PART 573 Defect and Noncompliance Report

This report serves as ASA Electronics LLC's ("ASA") notification to the U.S. Department of Transportation, National Highway Traffic Safety Administration ("NHTSA") pursuant to 49 CFR § 573 regarding its Voyager brand VOM74MM Mirror Monitor.

Manufacturer's assigned campaign number (where applicable): 19E-009

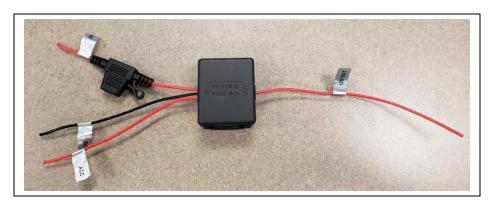
ASA performed a root cause analysis in cooperation with the fabricating manufacturer. ASA determined that the conditions causing the recall can be replicated on all revision A thru revision C. If a voltage drop (below 7 volts) takes place at a precise moment during powerup of the monitor (such as vehicle start) the monitor can skip the user defined settings and load the factory default settings which can invert the camera image on the monitor

Revision D changed the default settings for the image to match the user setting preventing this image from inverting.

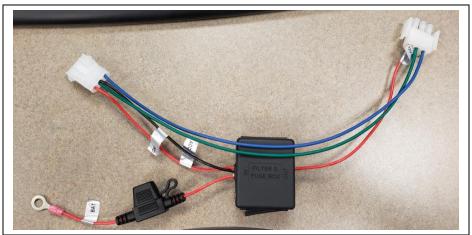
The alphanumeric serial code at the bottom of the label can be used to identify the affected items. As an Example (C1118SLCN02142) the first letter is the revision "C." The following four numbers are a date code in MMYY format. The affected products will have serial number starting with A, B, or C.

The recall population is different than similar items because <u>after Rev C</u> the default image setting matches the user image setting (starting at Rev D). Certain revision C units are quarantined at ASA Electronics. Any Revision C that are yet to be shipped will have an external capacitor/relay added into the wiring to prevent a voltage drop to the monitor (fix to be used in the field).

The field fix (relay/capacitor) module, which is approximately 1" x 1.5" x 1.5" is added to the wiring of the mirror monitor (mostly under the seat of the truck). See picture in section two above. Also, Rev D serial number will not invert the image if loading default settings.
